**BOARD OF ALDERMEN MEETING**
**Kearney City Hall 100 East Washington**
**5:30 p.m., MONDAY, June 23, 2014**

**<u>2A Kearney School Bus Maint Facility, 1001 N 33 Hwy, Rezoning to M-P and CU Permit for Aquifer Protection District</u>** A public hearing has been continued from the June 16th Board of Aldermen meeting to consider a request from the Kearney School R-1 School District for a rezoning request from M Industrial District to M-P Industrial Planned District and a Conditional Use Permit for a Vehicle washing station within the Aquifer Protection Overlay District at 1001 North 33 Highway (north of LPG Ventures).

**REQUEST:** **KEARNEY R-1 SCHOOL DISTRICT – REZONE FROM M – INDUSTRIAL TO M-P – INDUSTRIAL PLANNED DISTRICT AND ASSOCIATED CONCEPT/SITE PLAN & CONDITIONAL USE PERMIT FOR A VEHICLE WASHING STATION AND FUEL TANK WITHIN THE AQ – AQUIFER PROTECTION DISTRICT**

# SITE LAYOUT PLAN
# KEARNEY SCHOOL DISTRICT
# MAINTENANCE & TRANSPORTATION BUILDING

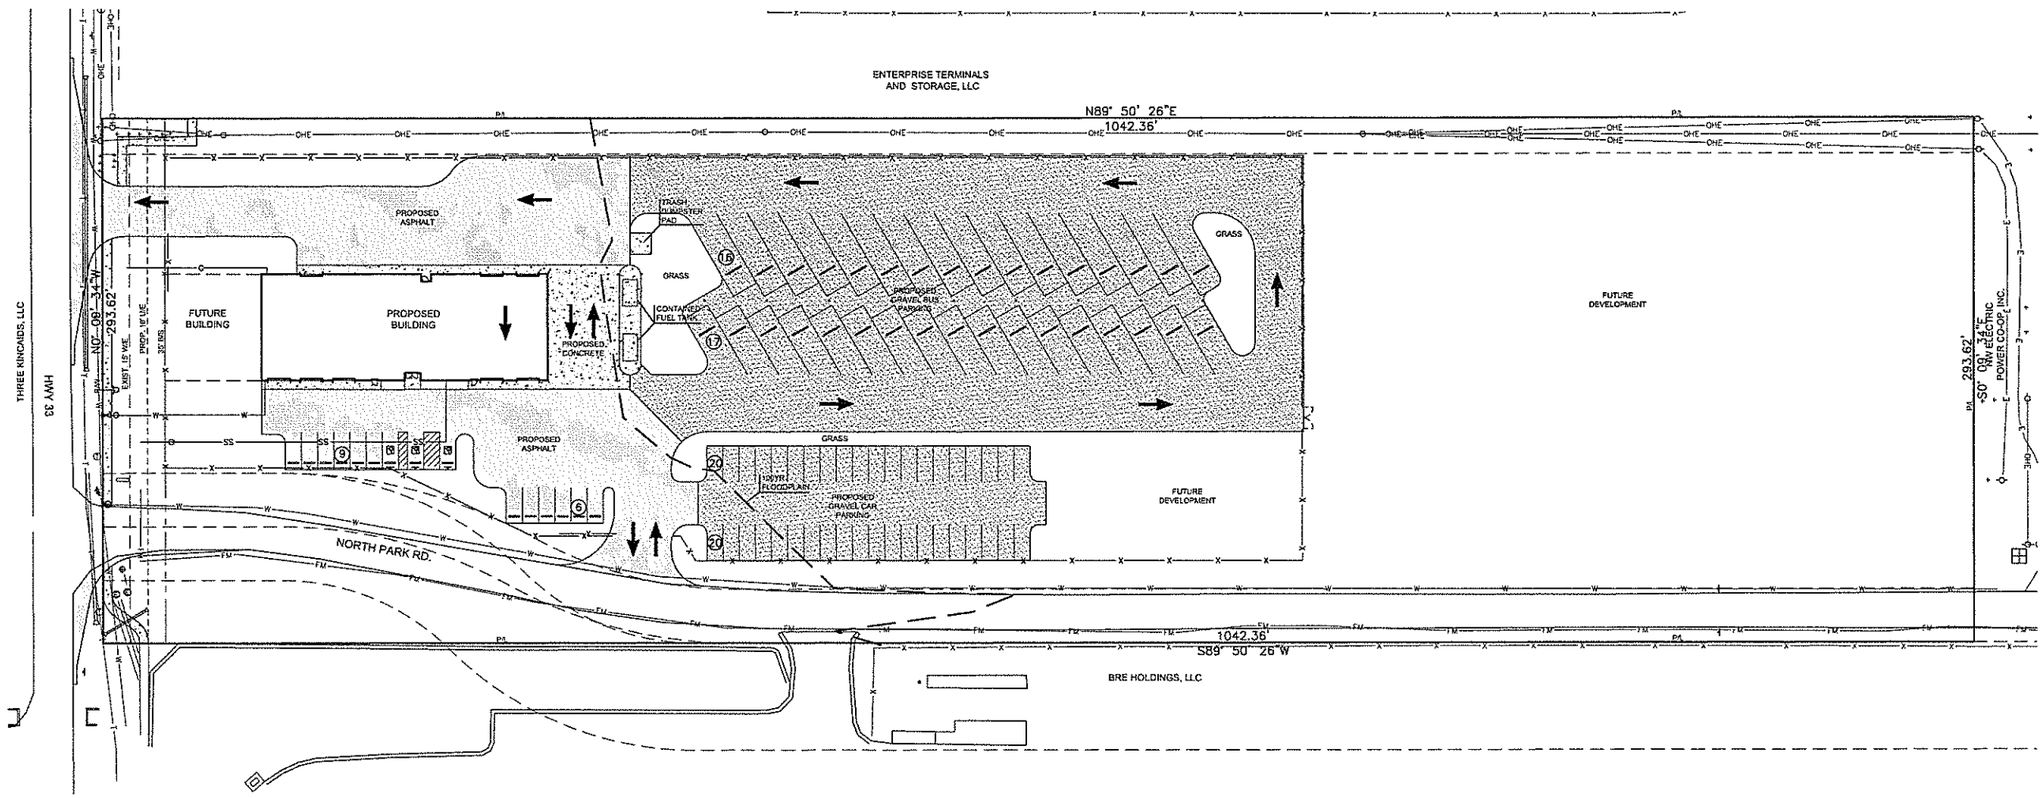
Kent Porter said if we move the setback from 50 feet to 35 feet and move the building forward will that interfere with a turn lane ever being put in that area. Staff said there would still be room. After some discussion it was decided that the setback is actually 25 feet and not 50 feet so that requirement could be removed.

Darren Hiley asked if the entrance onto 33 Highway in the Northwest corner would be out only. Staff said that is correct.

Kent Porter asked if the gray area on the map is gravel. Staff said that is correct.

Darren Hiley said he understands the no curbs but sheet run off always is in need of rip rap due to erosion.

Kathy Whipple asked about the fence around the property. Staff said it will be an eight foot chain link fence around the property.

Kent Porter asked about the bus parking spots and if they could manage getting into those spots. Mr. Oathout said they will back into the spots and the traffic engineers say they can do that.

Darren Hiley asked how they would mark the bus parking spaces in the gravel. Mr. Oathout said they would use curb stops.

Kathy Whipple said she was concerned about drainage. She said water will stand on that property. Mr. Oathout said the building will be raised and the parking lot will be graded to drain. He said they will use a geo grid sheeting to help keep the gravel from sinking as well as help control seepage into the aquifer.

PARKING: The project proposes 33 bus and 55 visitor/employee parking spaces, including 3 ADA parking spaces. Driveway areas and 15 of the visitor/employee spaces located along the building will be asphalt. The remaining parking spaces, for employees, and the bus parking area is proposed to be a gravel surface. As part of the M-P zoning, the district proposes to replace the gravel with asphalt/concrete by June 2020. Deferral of the hard surface will help make the project more financially feasible. In addition, over the course of the deferral period, the buses will better compact the gravel making for a stronger base when asphalt is installed.

1. Approval of the elimination of concrete curb and gutters, per the rezoning concept plan;
2. ~~Approval of deferral to construct asphalt paving for a portion of the site to 2020, per the rezoning concept plan~~ **All parking and drive areas to be hard-surface at the time of initial construction**;
3. Submittal of revised drawings prior to the Board of Aldermen meeting, including:
   a. Any further revisions, if necessary;
4. Installation of a key box, as required by the Kearney Fire & Rescue Protection District;
5. Submittal of a building permit application prior to construction;

1. Approval of the elimination of concrete curb and gutters, per the rezoning concept plan;
2. All parking and drive areas to be asphalt or concrete within 2 years;
3. Submittal of revised drawings prior to the Board of Aldermen meeting, including:
   a. Any further revisions, if necessary;
4. Installation of a key box, as required by the Kearney Fire & Rescue Protection District;
5. Submittal of a building permit application prior to construction;
6. Submittal of a sign permit with the building permit application or prior to installation of signs;
7. Development of the project in compliance with all codes, conditions, requirements, plans and payments of fees and taxes.

PAVING & DIMENSION PLAN
KEARNEY SCHOOL DISTRICT
MAINTENANCE & TRANSPORTATION BUILDING

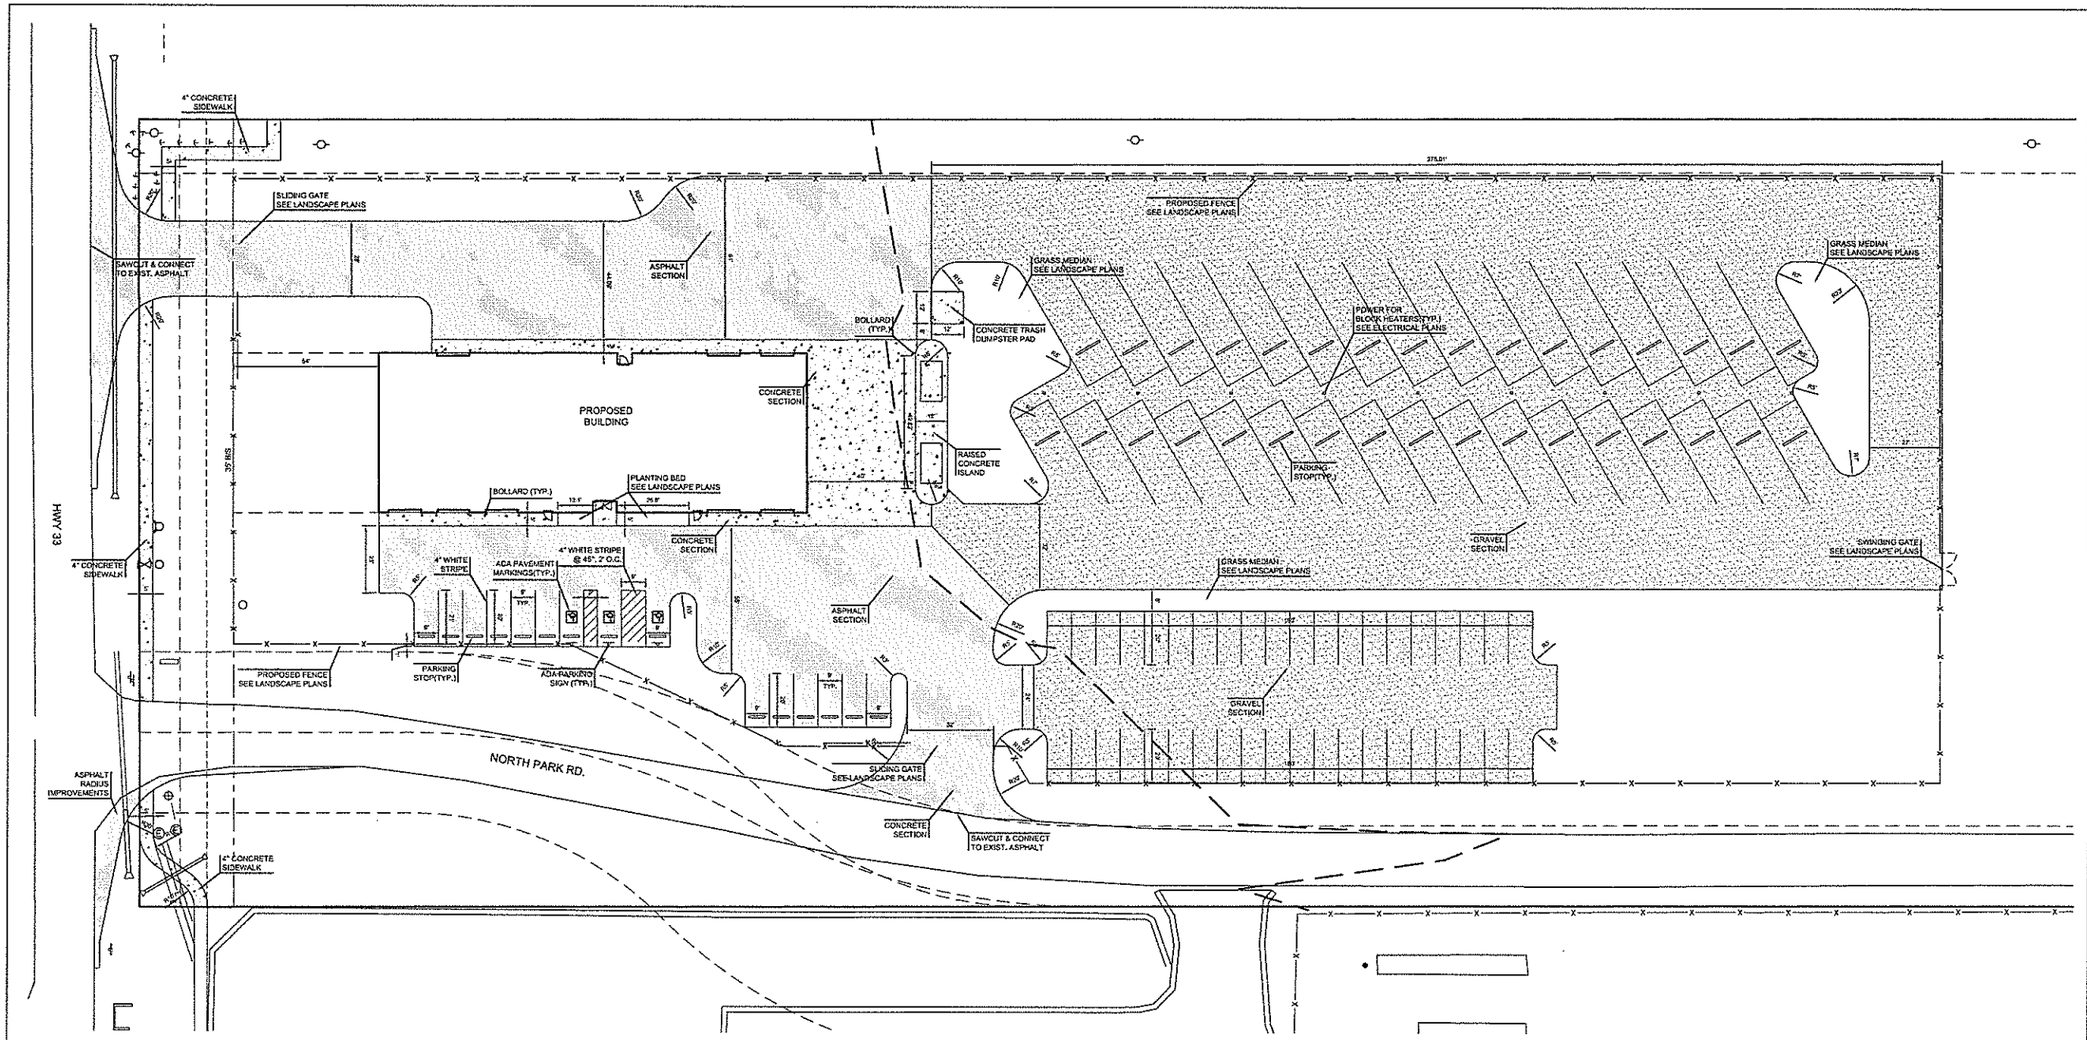
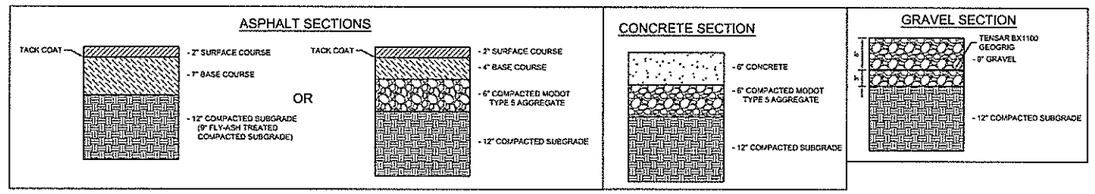
Kathy Whipple said she would definitely like to work with the School District but that is a lot of gravel for a long period of time.

## LANDSCAPE PLAN

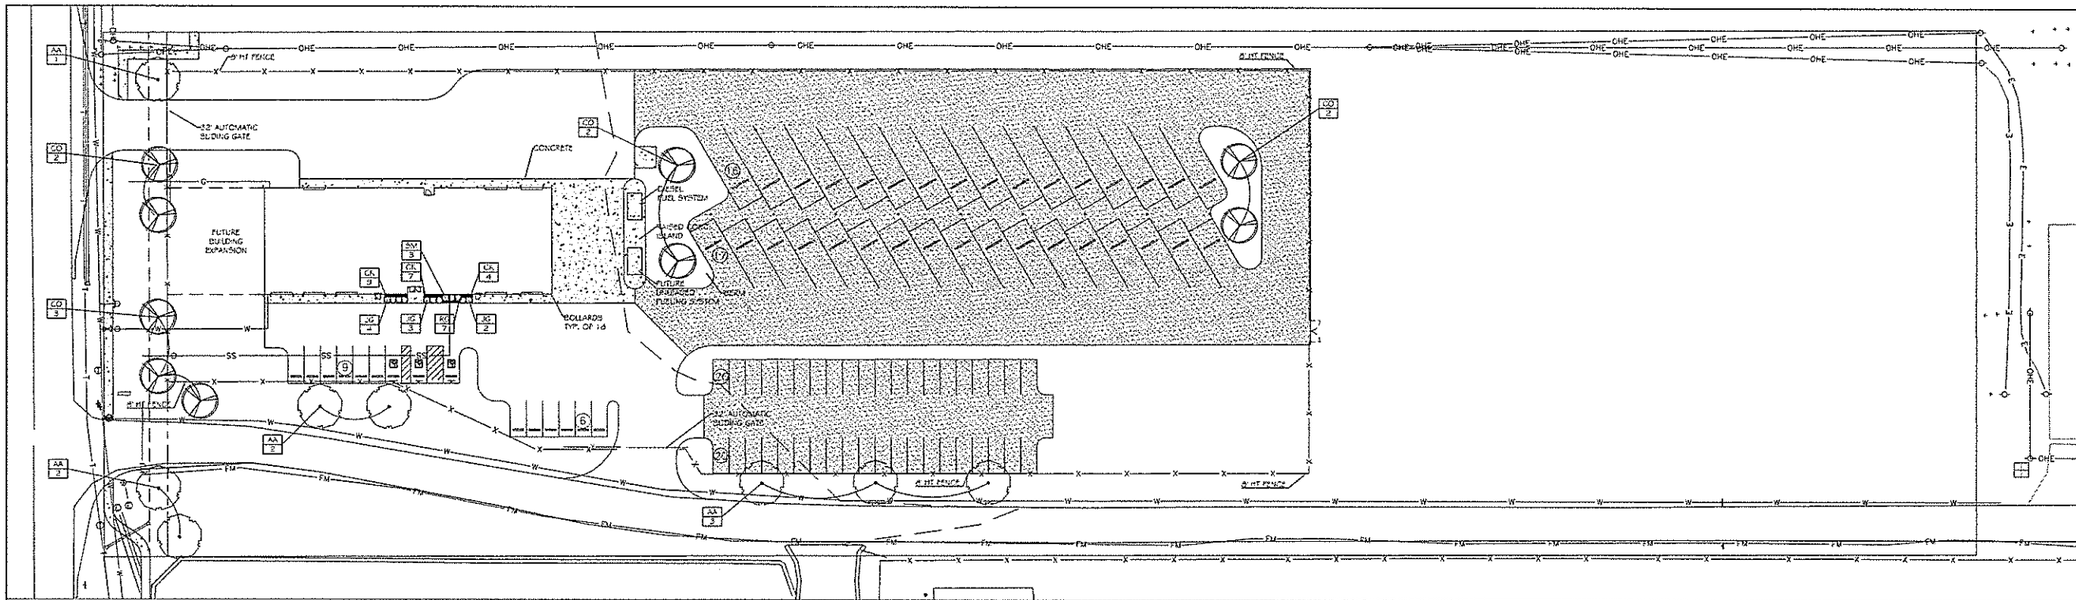
Kent Porter asked if there will be screening. Staff said there will be various trees located along the 33 Highway, along Park Lane, in the parking lot and along the front of the building.

LANDSCAPING: The landscape plan includes various trees located along the 33 Highway, along Park Lane, in the parking lot and along the front of the building.
